# Historic District Commission

## Staff Report – May, 2020

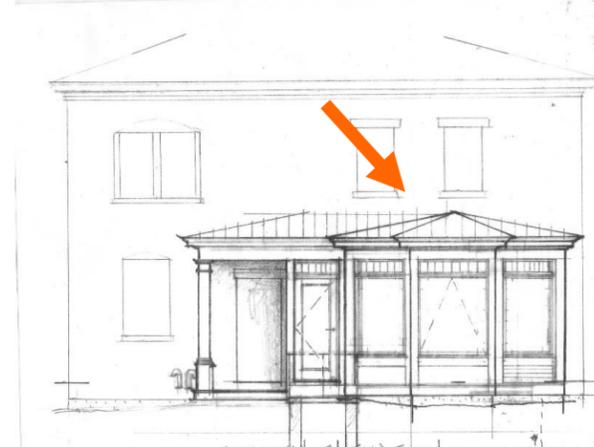
- Due to the meeting delays this project has been posted as a Work Session/ Public Hearing.
- The work proposed by the applicant is located along the rear elevation of the structure. The enclosed porch design has raised wood panels and is proposed to have a standing seam roof and large plate glass windows.

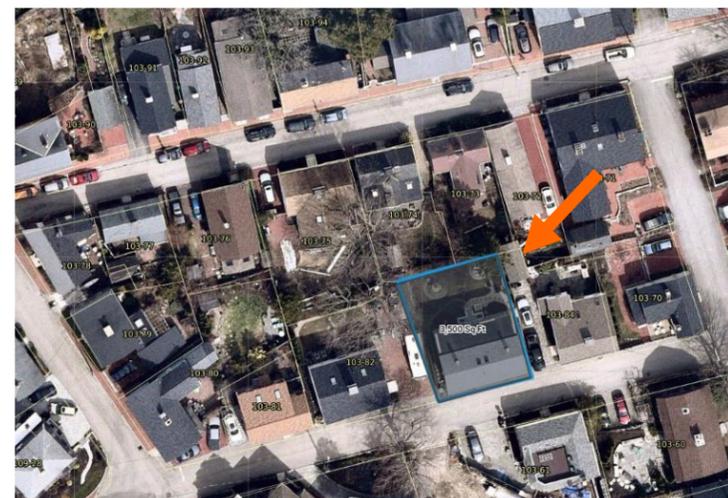
- To replace 5 front facing windows, 5 side facing windows and 3 rear facing windows with Green Mountain concealed balance replacement window or sash and balance with vinyl track replacement window. Windows will be replaced exactly as they are. 9 are currently 6/6 and will remain that way. 3 are 2/2 and will remain that way and 1 is 6/4 and will remain that way. The windows are approximately 110 years old and in fair to poor condition. Photos of all windows to be replaced are attached. Consistent with the Design Guidelines the applicant was directed to also explore window restoration as a preferred alternative.

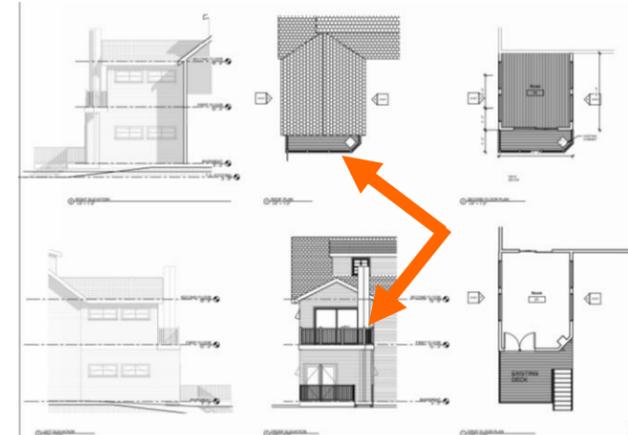
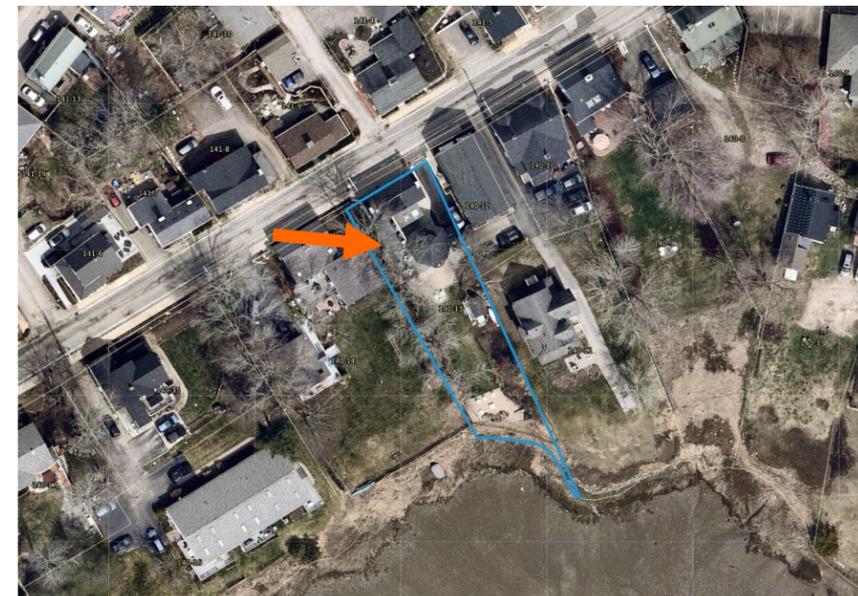
- The proposed rear addition is designed to match the existing style and appearance of the existing contemporary rear addition.

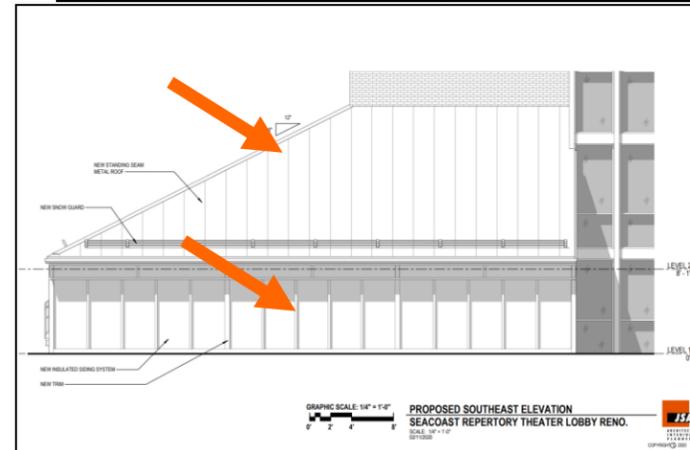
- The HDC previously reviewed this application on 2-12-20 and some members felt the proposed changes were character-defining changes that should be reconsidered to maintain some authenticity of this modern structure. For example, some members felt alternate panels should be explored to enable natural light to still enter the building.

Proposed Design and Street View Image of Existing Conditions

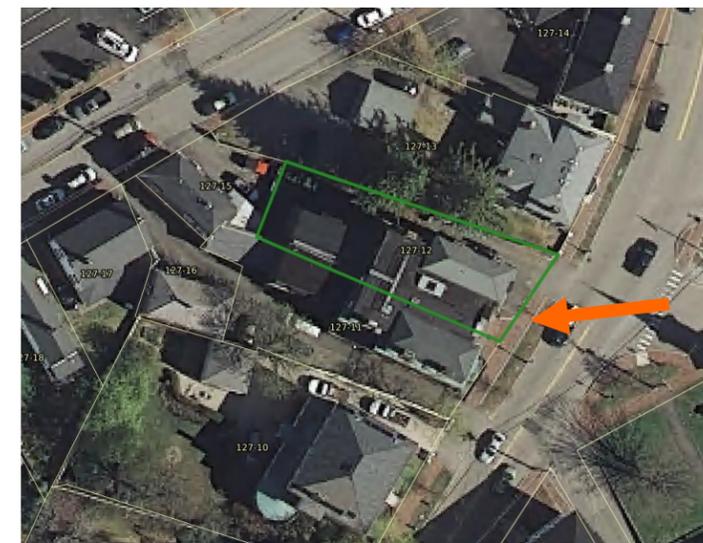
- The proposed improvements involve removal and replacement of contributing, character-defining and non-contributing materials.
- The front entryway is proposed to be a pre-case brownstone material which should be made to match the color of the existing brownstone and sample should be requested.
- The front doors should be considered for restoration given they are original to the structure.
- Revised elevations will be provided prior to the May 13<sup>th</sup> meeting.

Proposed Design and Street View Image of Existing Conditions

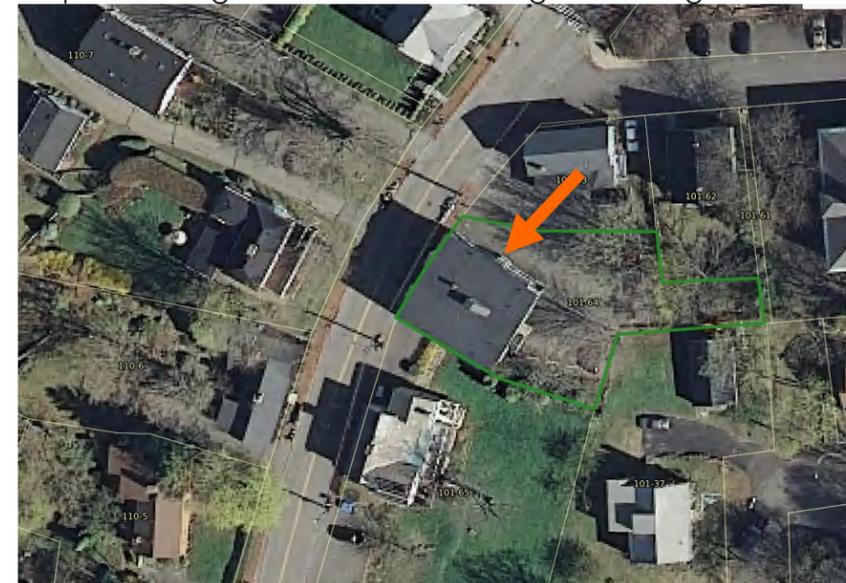
- The HDC previously reviewed this application and suggested the applicant consider a more traditional railing system on the street-facing façade with no curve on the balconies and modifications to the stairwell on the roof to minimize its appearance. Other comments included adding darker storm windows and a darker color on the exposed foundation.

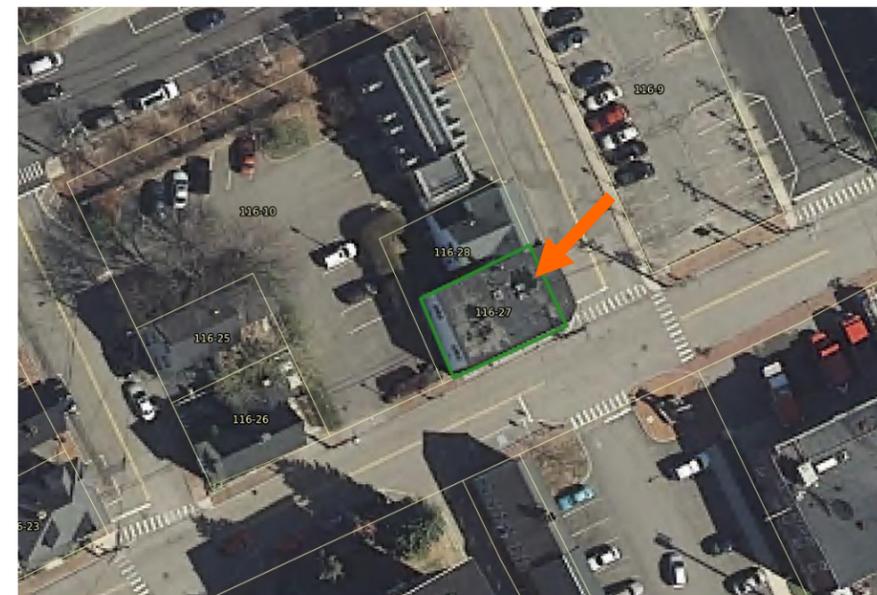
- The HDC previously reviewed this application and several members expressed a preference for the glass (tinted) canopy with more architectural detailing on the tiebacks for the canopy and leaving the exposed brick foundation unpainted.

- The proposed improvements include adding new storefront windows and a new canopy along the sidewalk.

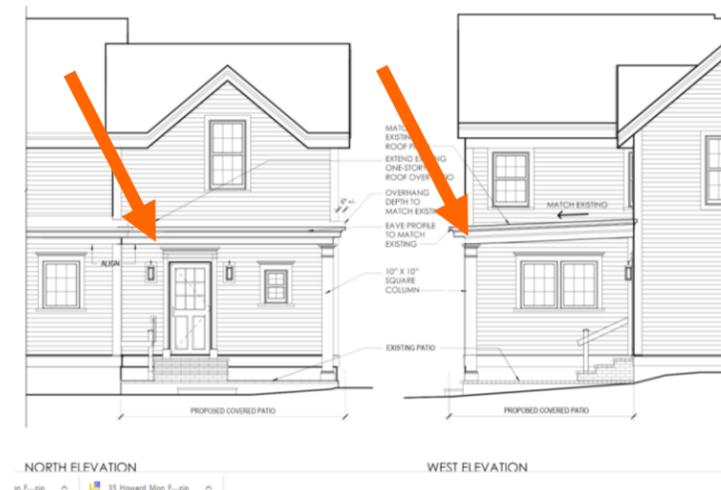
- The HDC previously reviewed this application and suggested a smaller column diameter and that it should be relocated closer to the edge.

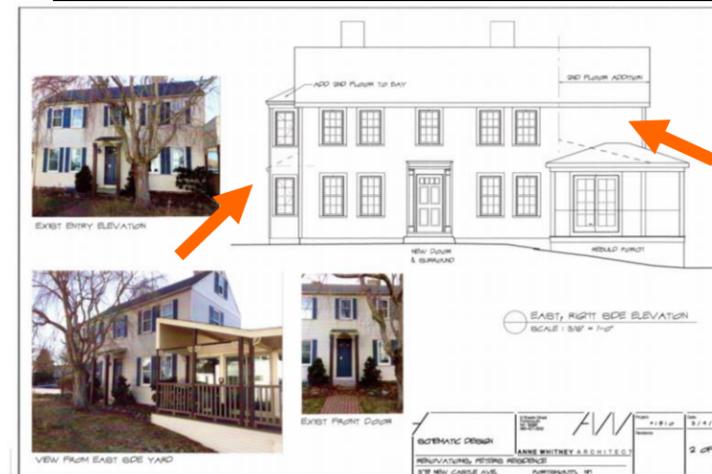
- A two-story addition to the front, side and rear elevations
- Replace the porch
- Reconstruct the chimneys from brick versus stone.
- Replace windows and doors, siding and trim.

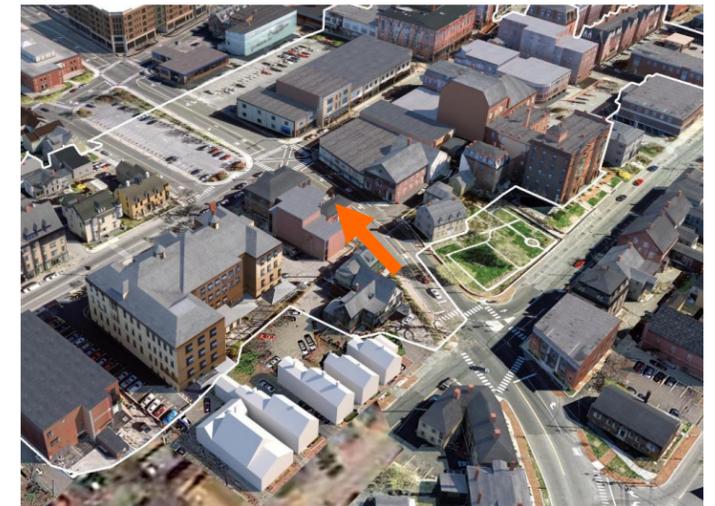
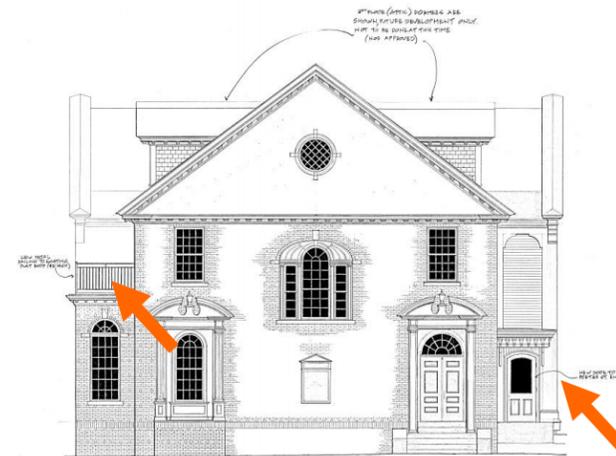
- Install non-combustible siding for fire separation.
- Shorten CMU building to provide dumpster storage.
- Note – the dormers shown on the elevations are NOT proposed under this application.
